# Final Drainage Report

## Townhomes at Western

Lot 1, Cimarron Southeast Filing  
No. 2C

PCD File No. PPR-24-15

**FINAL DRAINAGE REPORT**  
EXISTING CONDITIONS

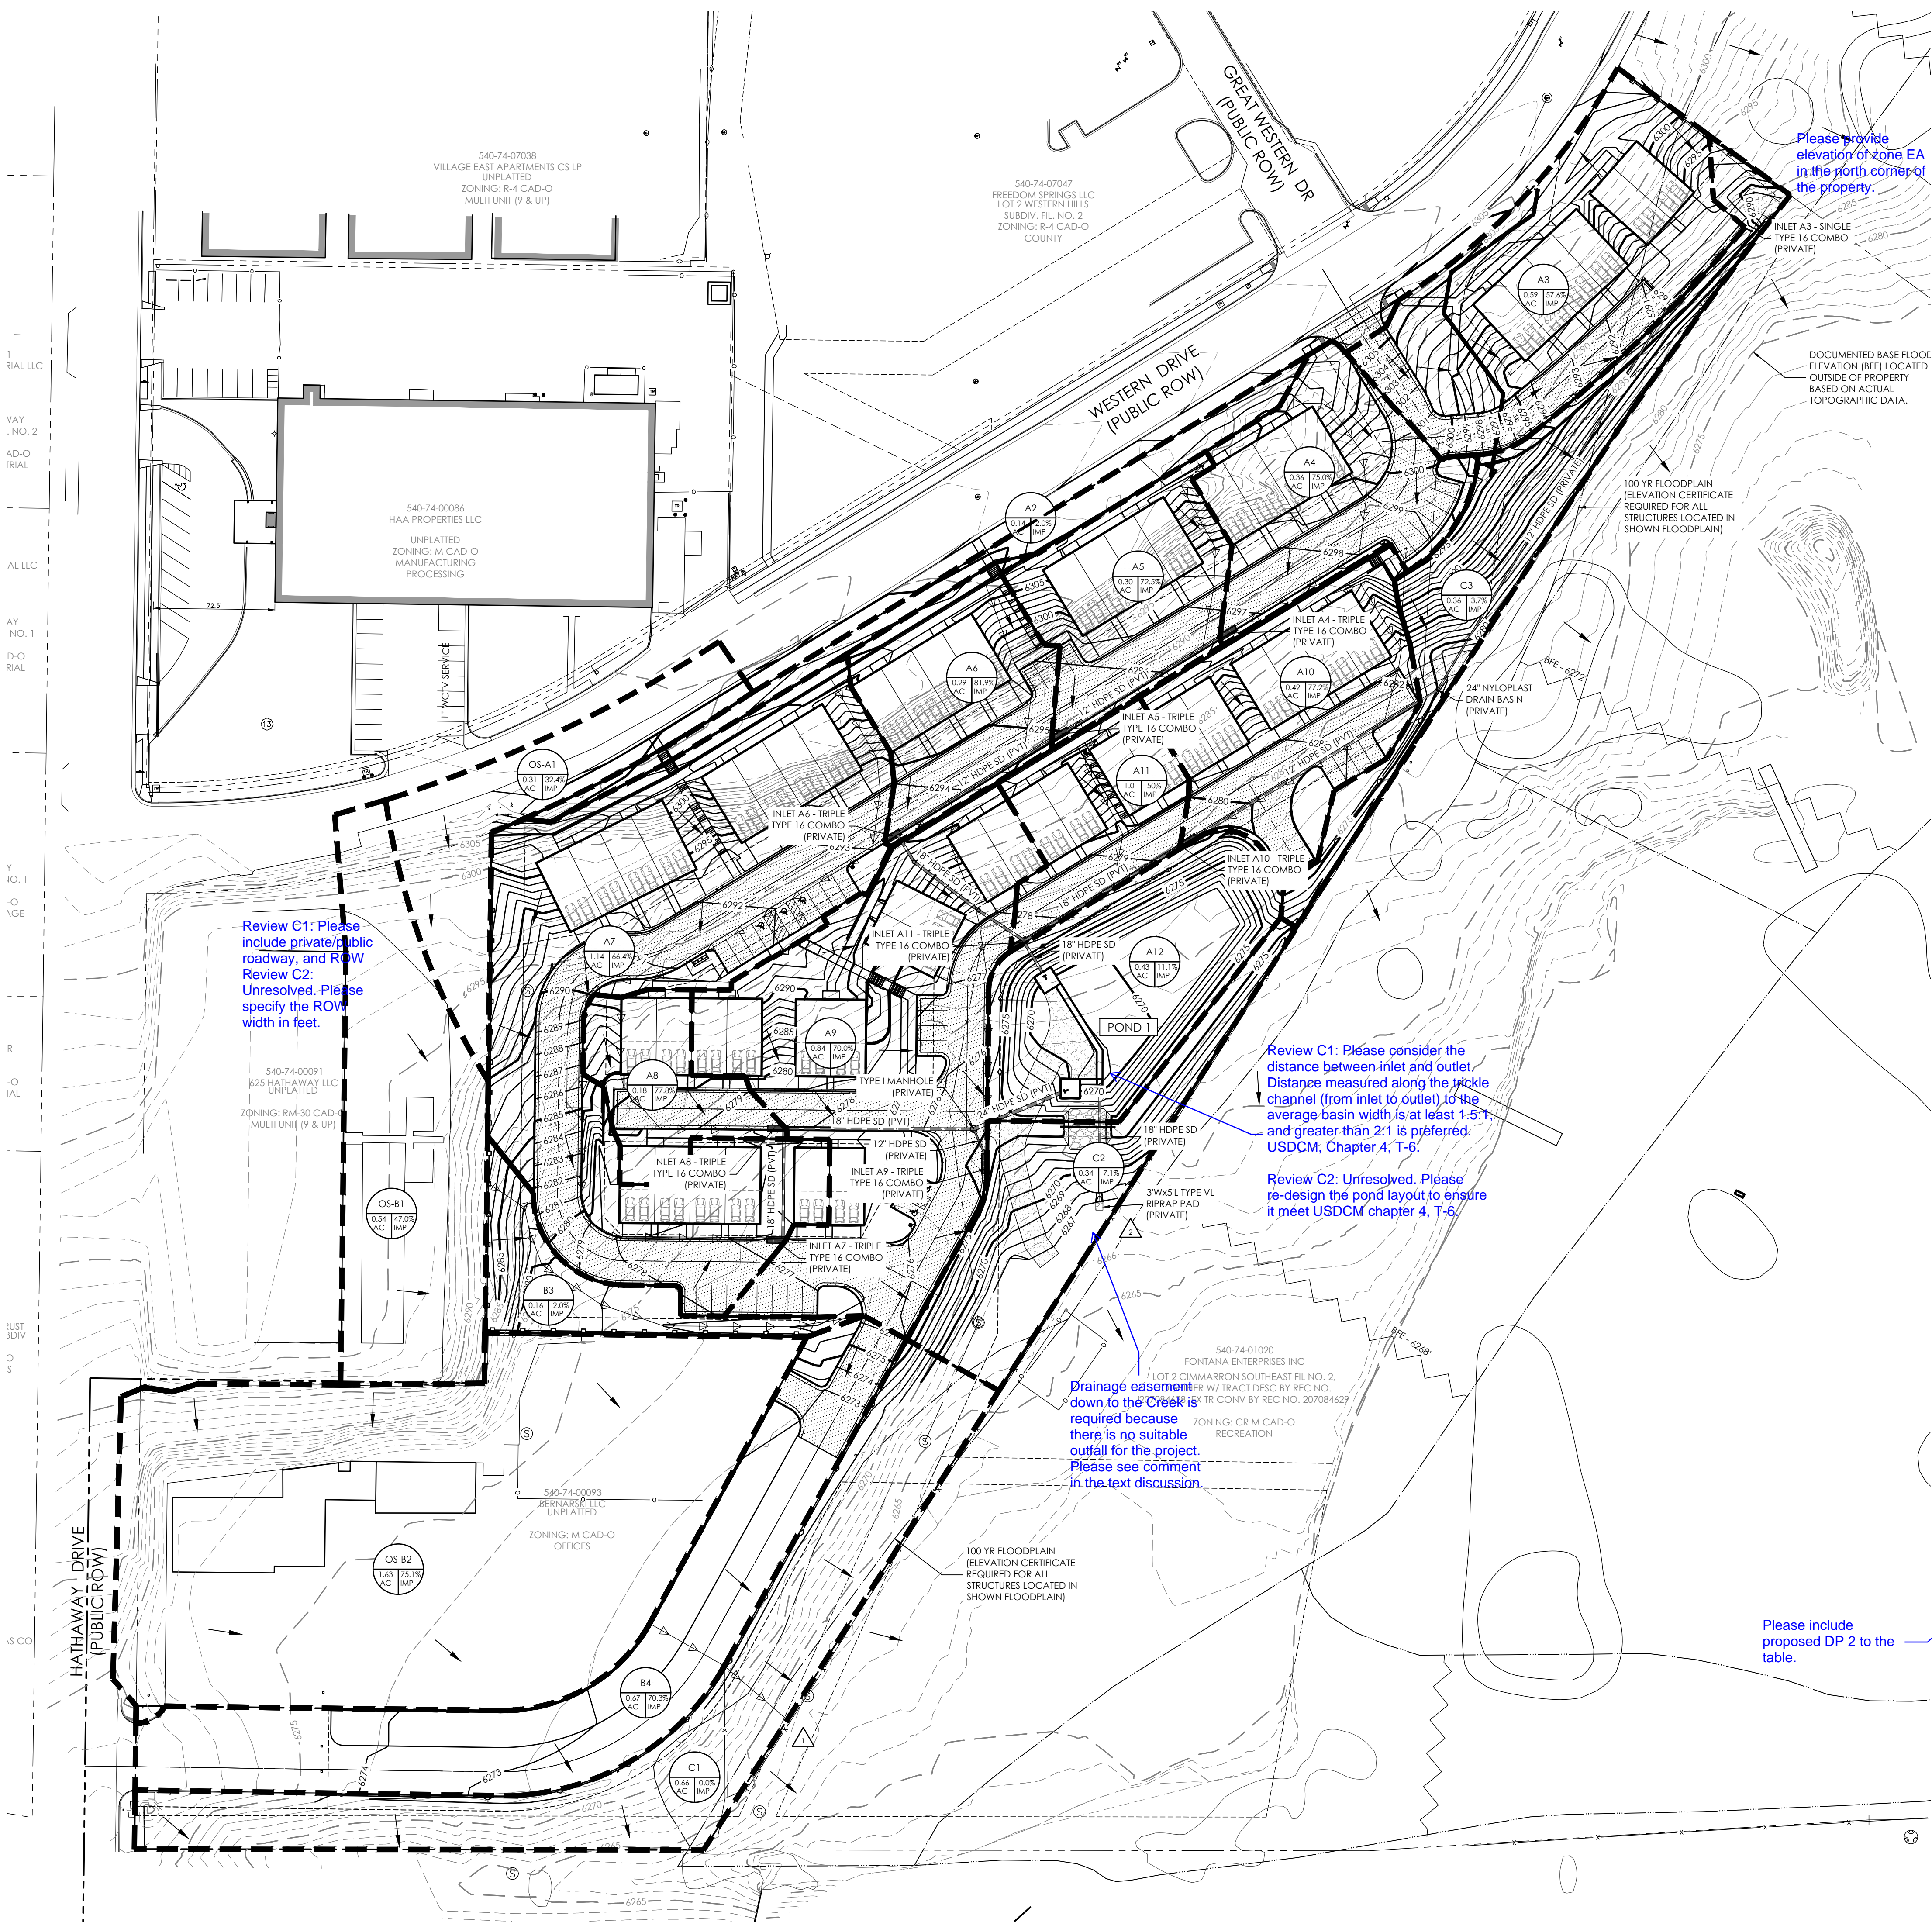
Please divide the EX-A2 basin into two smaller basins because the runoff from the entire basin does not flow towards the existing DP2. Please recalculate based on this information. This comment is prompted by the initial review cycle where the direction of runoff flow was not provided.

Please provide elevation of zone EA in the north corner of the property.

Drainage easement down to the Creek is required because there is no suitable outfall for the project. Please see comment in the text discussion.
